# HISTORIC AND DESIGN REVIEW COMMISSION

**HDRC CASE NO:** 2018-451  
**ADDRESS:** 607 E LOCUST  
**LEGAL DESCRIPTION:** NCB 1735 BLK 14 LOT 3  
**ZONING:** MF-33 H  
**CITY COUNCIL DIST.:** 1  
**DISTRICT:** Tobin Hill Historic District  
**APPLICANT:** Jose Calzada/Architectura SA  
**OWNER:** Rafael Saavedra Sada/Aster Development LLC  
**TYPE OF WORK:** Construction of a 3-story, multifamily structure  
**APPLICATION RECEIVED:** November 14, 2018  
**60-DAY REVIEW:** January 13, 2018  
**REQUEST:**

The applicant is requesting conceptual approval to construct a 3-story multifamily structure on the vacant lot addressed 607 E Locust. The request also includes rear surface parking for approximately 8 cars, additional hardscaping, and landscaping.

1/4" = 1'-0"

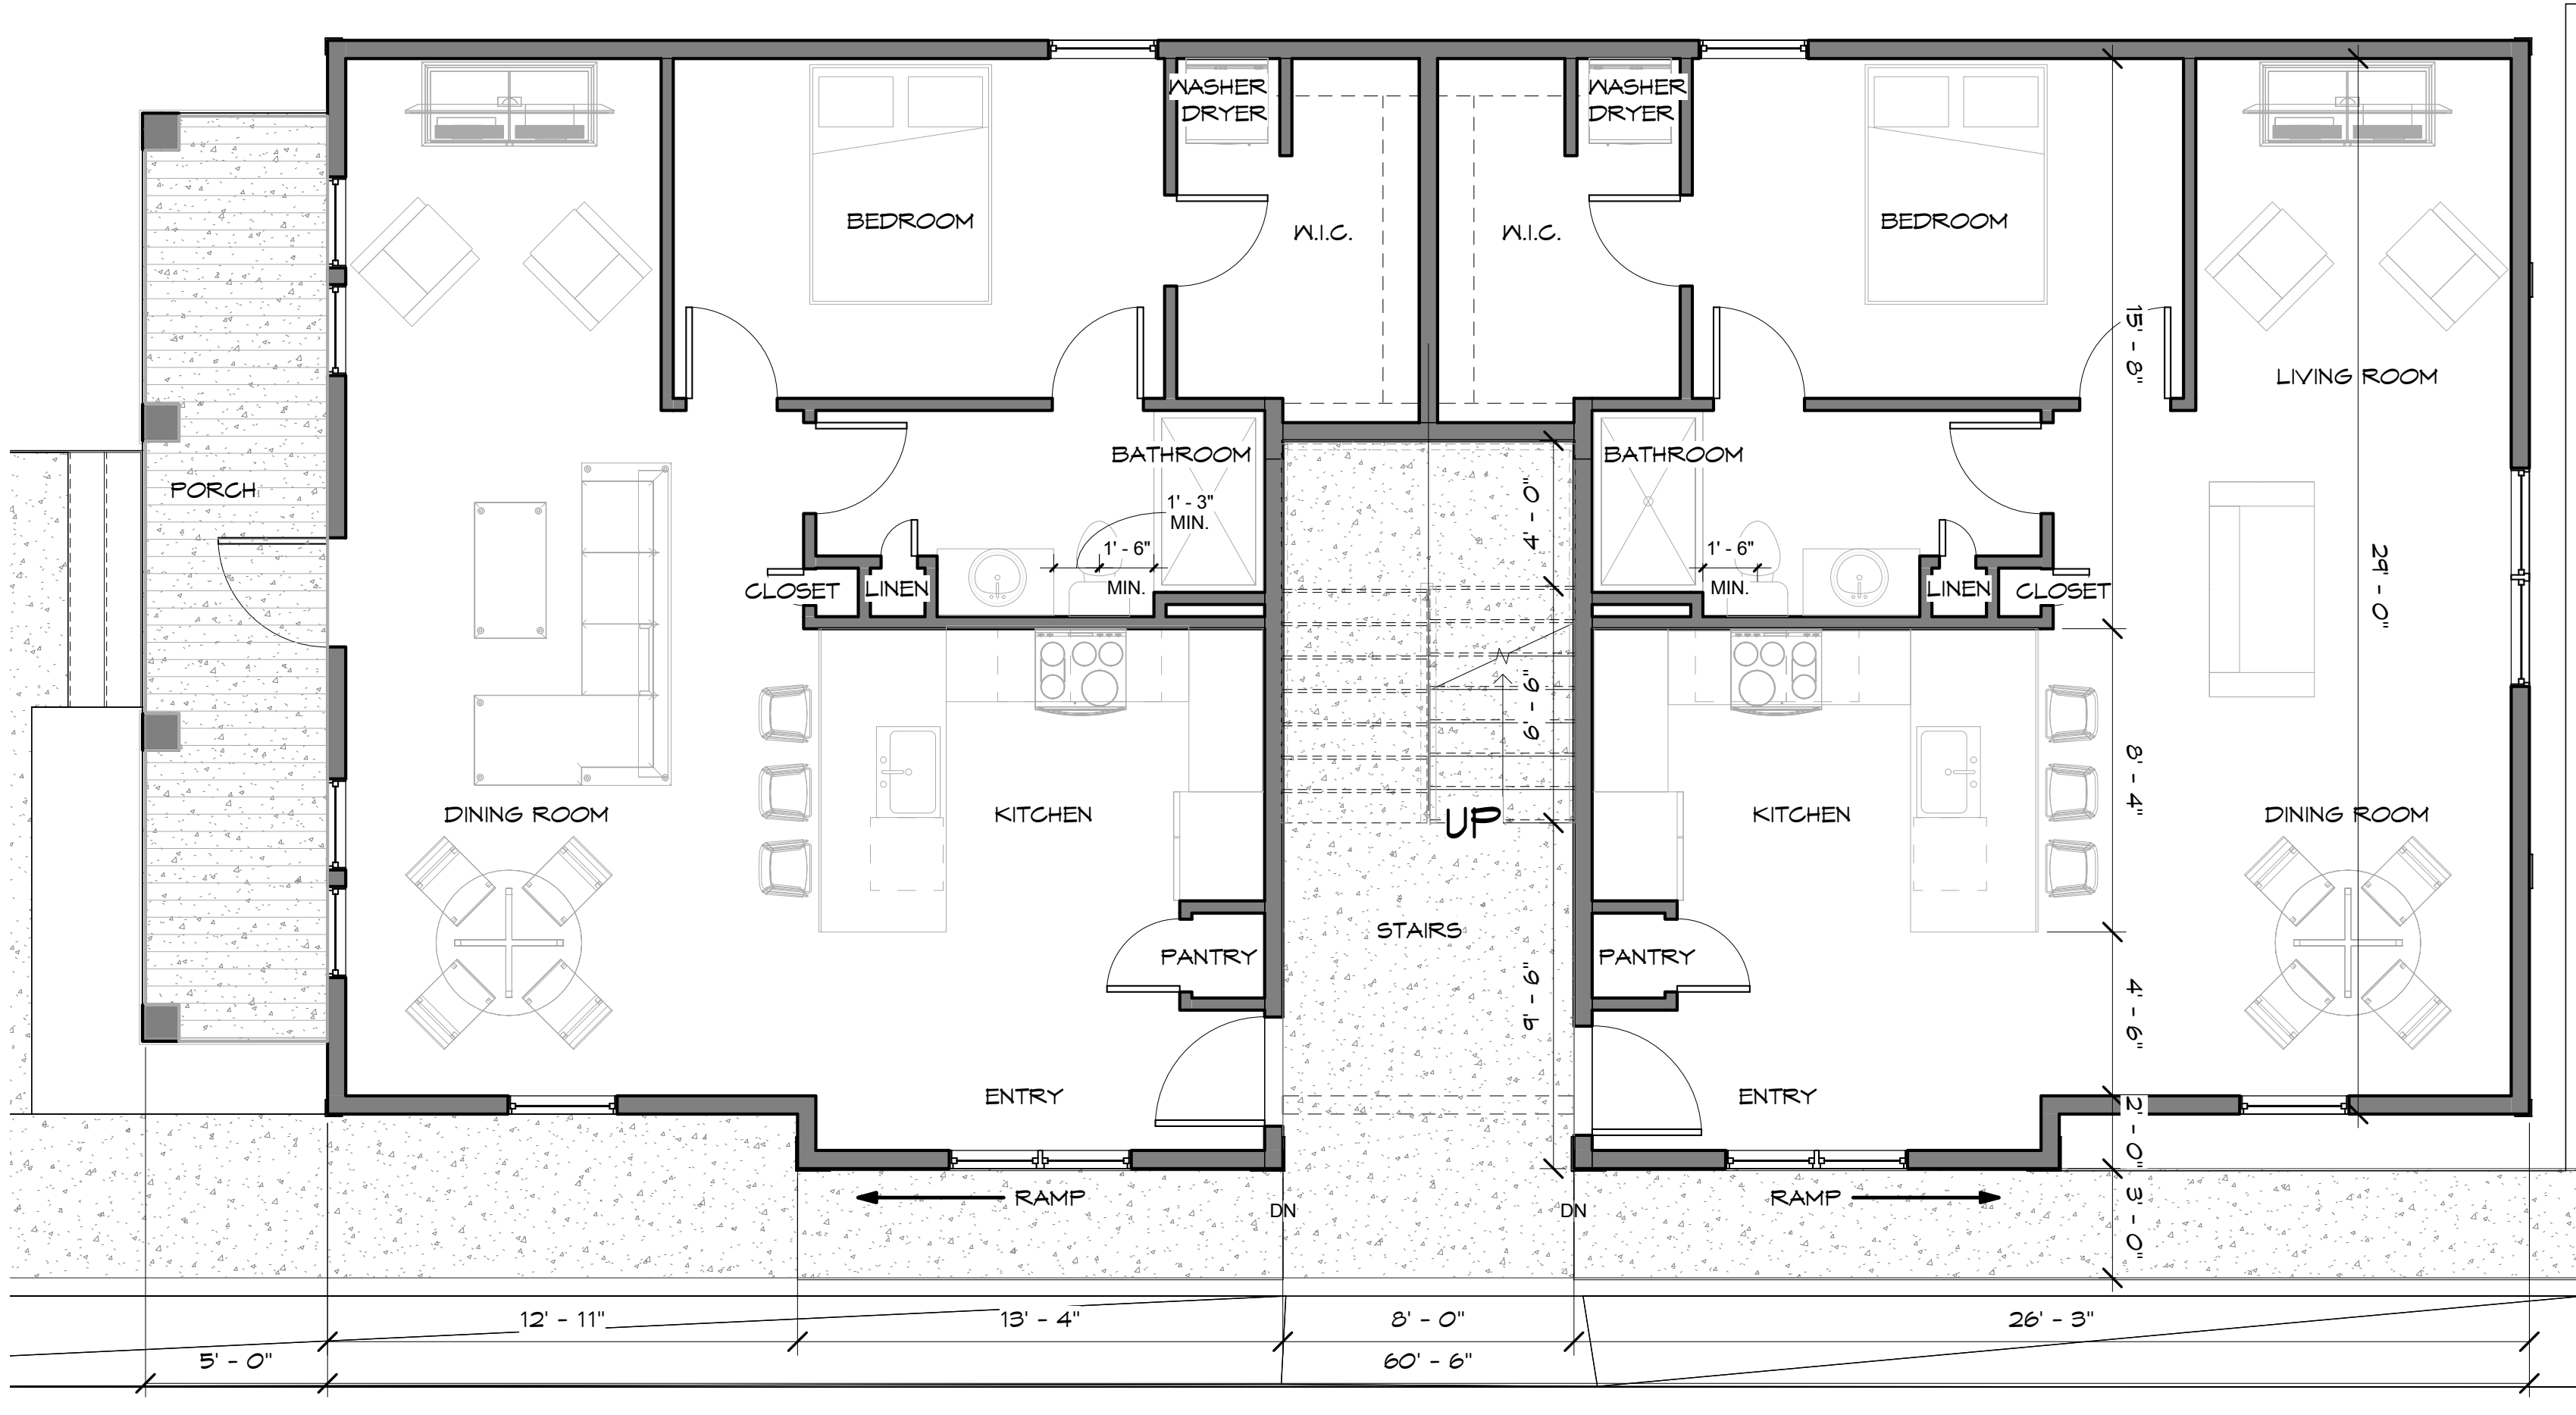
- g. **SCALE & MASS** – The applicant has proposed one, 3-story unit. Per the submitted elevations, the ridgeline of the units is approximately 31'. Guideline 2.A.i stipulates that the height and scale of new construction should be consistent with nearby historic buildings and should not exceed that of the majority of historic buildings by more than one-story. Per the submitted elevations, the applicant has indicated that the 2-story historic structures directly to the east and west are approximately 30-31 feet. Staff finds the overall height to be generally acceptable given the specific context of this portion of the E Locust and the district.

- h. **FOUNDATION & FLOOR HEIGHTS** – According to the Guidelines for New Construction 2.A.iii., foundation and floor heights should be aligned within one (1) foot of neighboring structure's foundations. Throughout this block, the foundation heights of historic structures are between two and three feet. The proposed foundation height is approximately 1.5 feet. Staff finds this consistent with the Guidelines.
